**THE TOWN OF TICONDEROGA**

**VETERAN'S ROAD CULVERT REPLACEMENT  
OVER FIVE MILE CREEK  
PIN 1761.09, D036296**

**AMENDMENT NO. 2**

**May 3, 2022 LETTING DATE**  
(Issued April 27, 2022)

**JOINT RECESS DETAIL**  
NOT TO SCALE

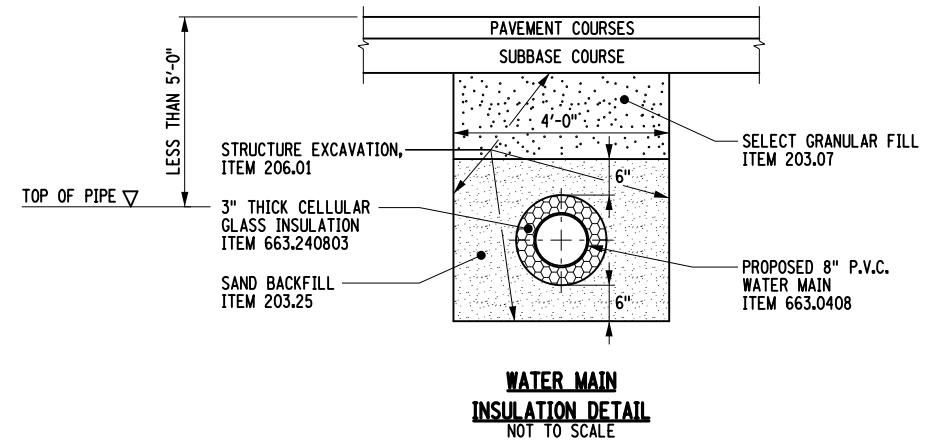
Old Sheet	New Sheet	Drawing #	Description of Changes
20	20A	ST-12	Updated callout on Joint Recess Detail to clarify payment of item
23	23A	ST-15	Updated Steel Bridge Railing Detail to add drilling and grouting of anchor studs
28	28A	EQQ-1	Added Item 586.0201. Corrected Item 563.07000001 from 563.07.

Contractor Question: There is no longer a Centerline Keyway as the panels were saw cut at the joints. Do you have a grouting detail for this new joint?

**It is assumed that the contractor will chip away the existing grout and refill the existing keyway with new grout once the panels are set in place. Alternatively, if the existing shear keys are missing or damaged beyond repair as determined by the engineer, then the joint will be sealed per the Joint Recess Detail on sheet No. 20 of the contract plans. This work will be included in the unit price bid for Item 563.07000001.**

FILL THE RECESS WITH A STRUCTURAL JOINT MATERIAL, SILICONE SEALANT, FROM THE DEPARTMENT'S APPROVED LIST FOR ITEM 567.51-16. IF THE RECESS IS SAW CUT, WATER BLAST IMMEDIATELY FOLLOWING CUTTING TO REMOVE ANY RESIDUAL SLURRY BEFORE IT DRIES. CLEAN THE VERTICAL FACES OF THE RECESS BY ABRASIVE BLAST, AND AIR BLOW THE RESIDUE FROM THE RECESS. PRIME THE VERTICAL FACES WITH THE MANUFACTURER'S RECOMMENDED PRIMER, AND ALLOW TO DRY. PLACE A 5/8" DIA. SOFT CLOSED CELL BACKER ROD IN THE BOTTOM OF THE RECESS. POUR THE SILICONE SEALANT TO A DEPTH OF APPROX. 5/16". PAYMENT TO BE INCLUDED IN THE UNIT PRICE BID FOR THE APPROACH SLAB. ITEM 555.09
